Project: Aquatic Facilities Maintenance Rehabilitation
Wilson Senior High School
The Wilson School District
2601 Grandview Boulevard
West Lawn, Pennsylvania 19609

Date: 29 MAR 2021

ADDENDUM 01

Project Number: 20755
 CONTROL JOINT PLAN

AP101

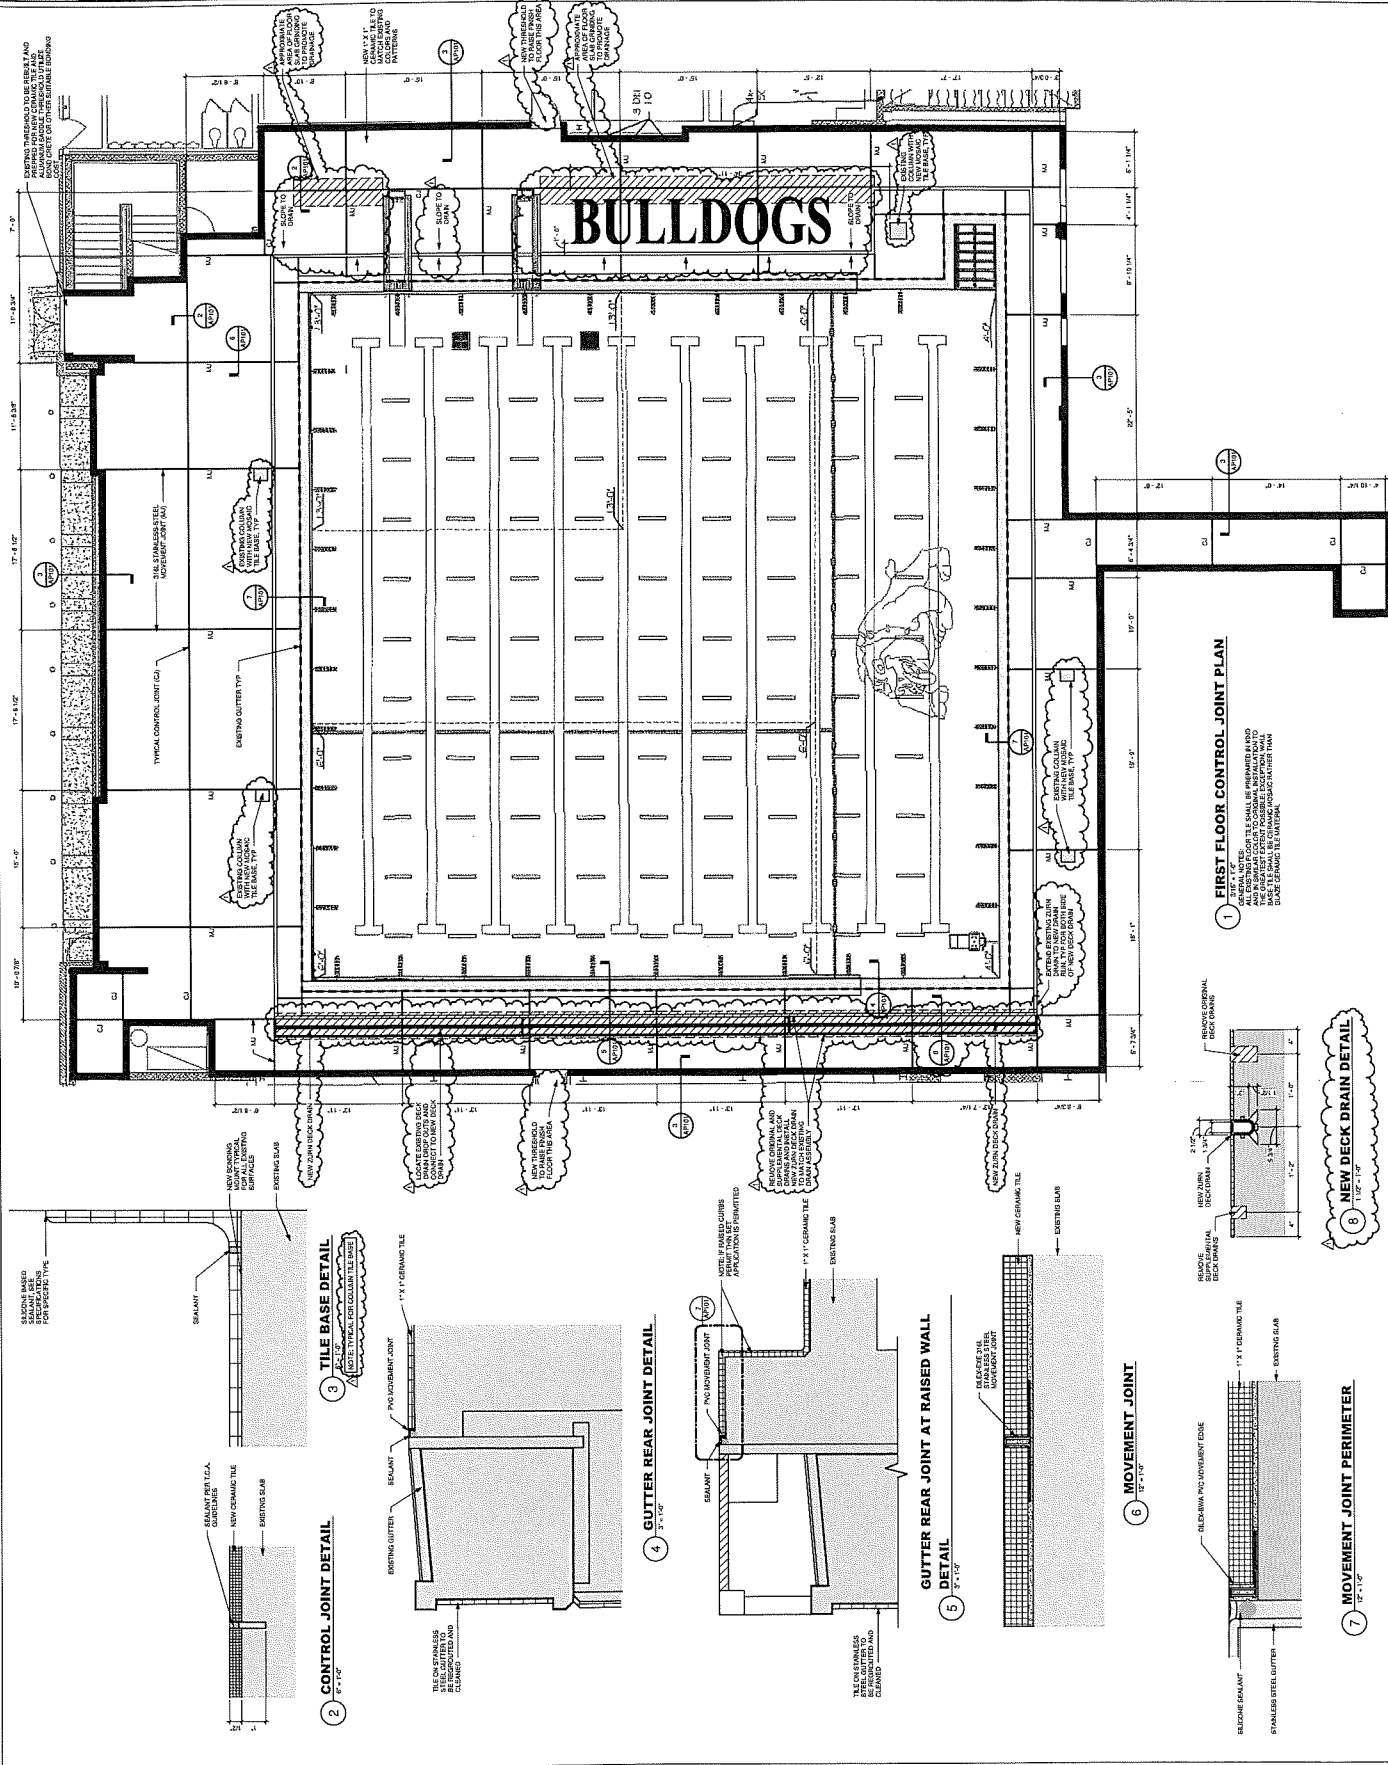
1. Sheet AP101 Control Joint Plan
 - a. Revise area of flooring to be reshaped (limited grinding and milling to remove high points in several locations) to improve slopes and drainage to existing drains to remain. No thick set leveling setting bed material was installed in the original installation. The original installation was installed with a thin-set installation directly on concrete pool decks. This will dictate the use of thin set for the remediation work with crack isolation and smoothing membranes to enhance draining on the pool decks.

- b. Remove existing original Zurn drain, (Model Z880, 2-1/2" x 48" x 3") and supplemental deck drain on starting block headwall side of the pool and install a single run of new deck drain of similar size and manufacturer (Zurn, Model Z880, 2-1/2" x 48" x 3") to promote proper drainage.

- c. Install new marble thresholds to men's locker room and pool equipment rooms to enable additional slope to the deck drain. Verify height in field, match threshold width to align with existing floor tile scheduled to remain.

- d. Adjust floor section details to reflect thin-set tile installation on concrete decks rather than a full setting bed set application.
